PLAN AND SPECIFICATION QUESTIONS

Project Name: Vibra Bismarck Rehabilitation Hospital
Architect: EAPC
Bid Date: February 19, 2025

21 A921 RESTROOM FINISH INSTALL
1/2" = 1'-0"

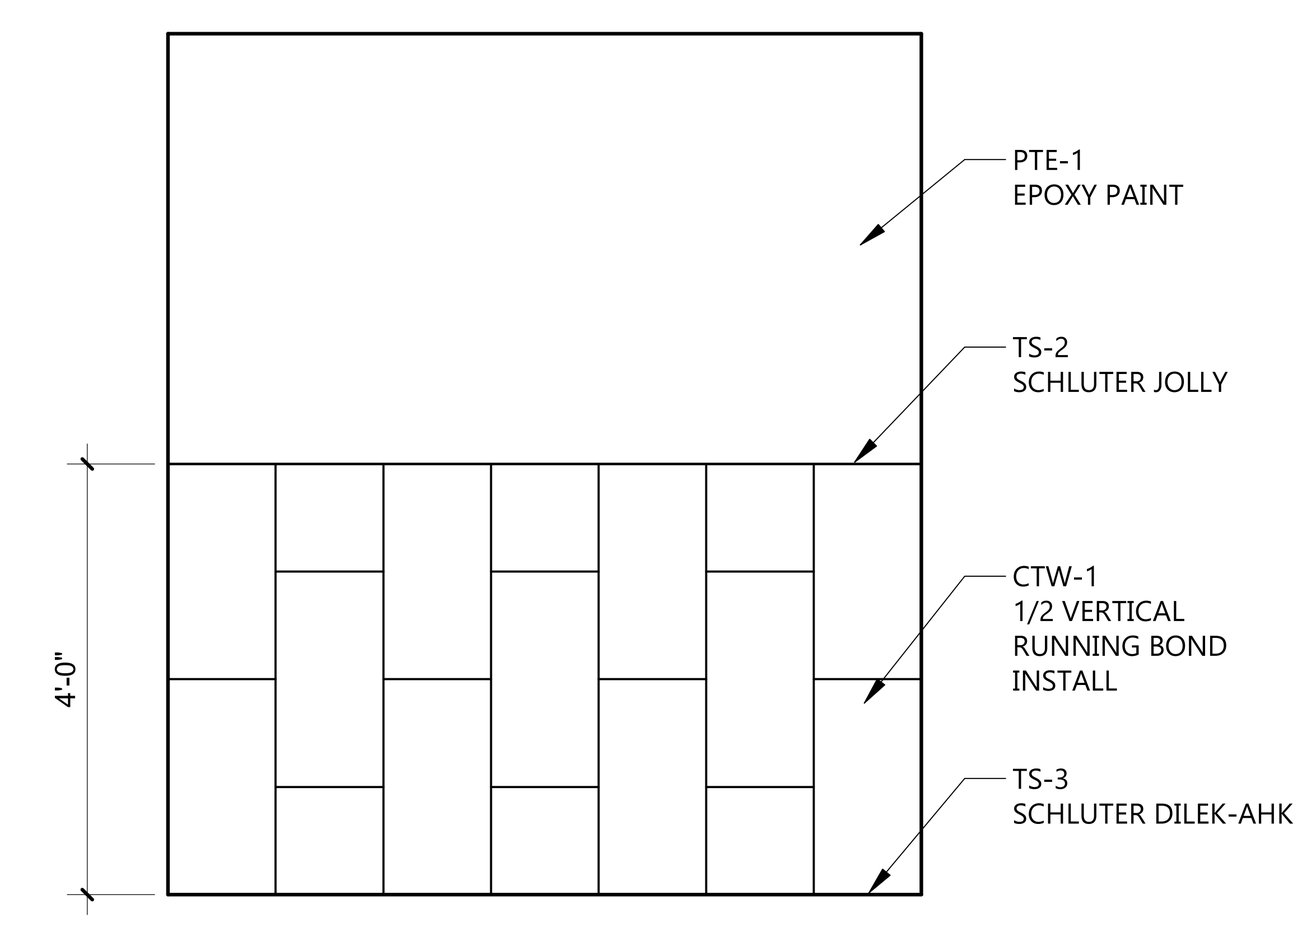
53	A901.A, A901.B, A902.A, A902.B, A921	1/30/2026	The A901 and A902 series sheets have several locations that indicate a note for "SEE 21/A921 FOR ALL WALL FINISHES", this note is used both staff and patient restrooms. Is detail 21 to apply to all of those locations where 4'-0" tile is shown, and details 18, 19, and 20 on A921 only applicable for the locations where showers are specifically present? Please confirm.	Confirmed. Detail 21 on A921 is to indicated the install pattern and height and any other trims and accessories related to the tile install on the walls. Details 18, 19, & 20 are to indicated specifically the solid surface shower walls and all of the trims and accessories for that installation.
54	A901.B	1/30/2026	Sheet A901.B indicates FRP lining the entire Kitchen, Admin Corridor, Receiving Alcove, and Soil room. What height should this be installed to? Is this supposed to be FRP and not wall protection? If this is to be wall protection, what type of wall protection should be provided?	FRP as indicated. Installed above 6" high integral coved base, refer to detail 11/921. 4' high above base. Sheets to be ordered in 4' x 8' sheets as noted in finish materials list.

1 P200 UNDERGROUND PLUMBING PLAN
1/8" = 1'-0"

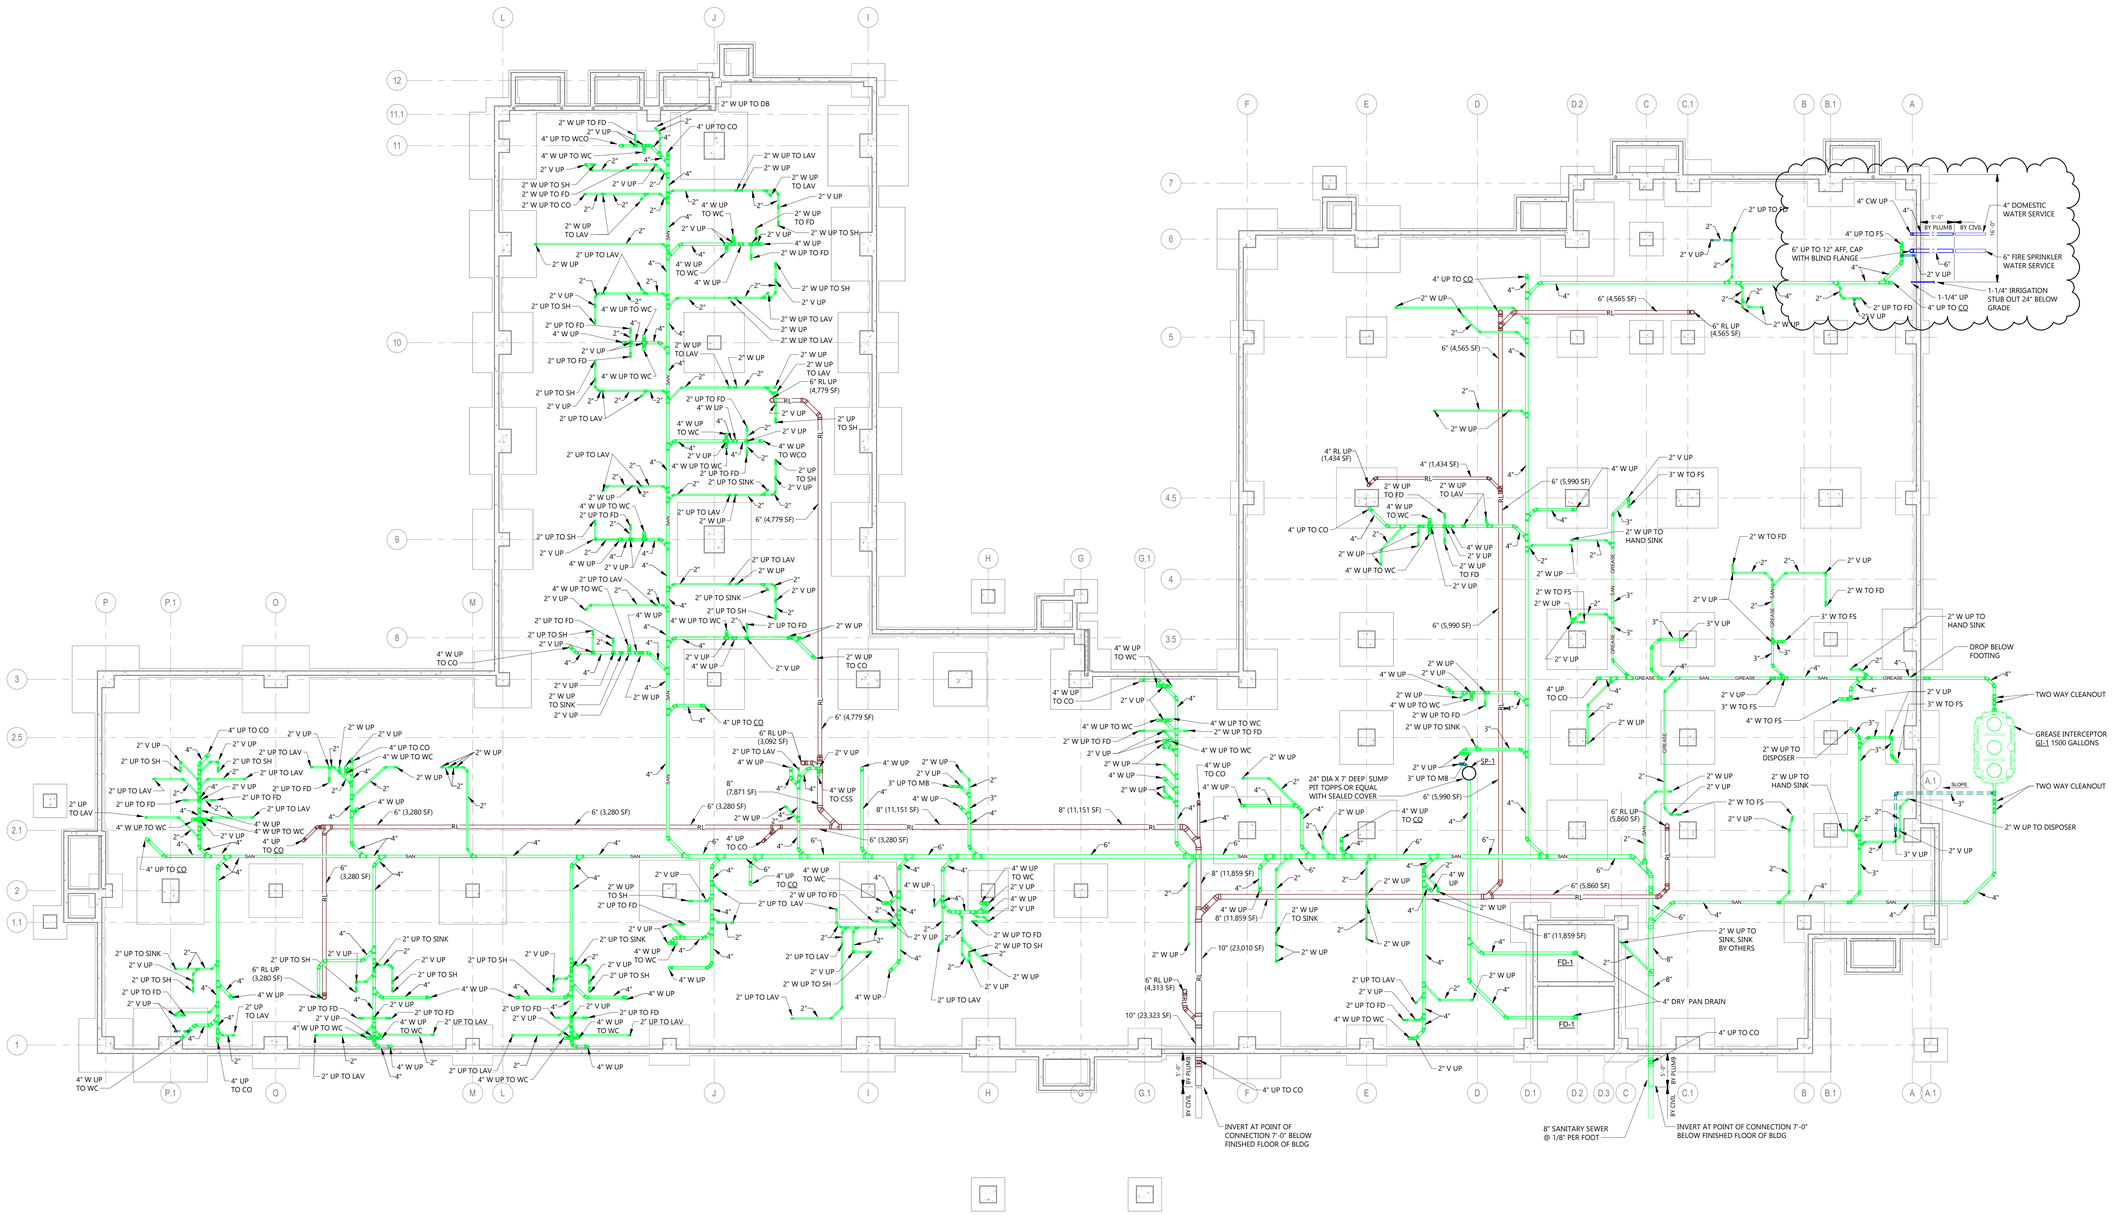
28	P200 / C3.0	1/30/2026	P200 indicates (1) 4" domestic water service, (1) 1" emergency water service, and (1) 6" fire sprinkler service near the Northwest corner of the building, however sheet C3.0 only shows (1) 4" domestic water service and (1) 6" emergency fire service. No 1" emergency water service is shown on C3.0. Please revise C3.0 to include this 1" emergency water service, revise P200 to remove it, or advise how the 1" emergency line on P200 is to connect to the civil piping outside of the building footprint. If this 1" line is connected to the same line as the 4" main, what happens when there is a utility issue with the main line coming to the building?	CIVIL NEEDS TO PROVIDE AN ADDITIONAL 1" WATER SERVICE
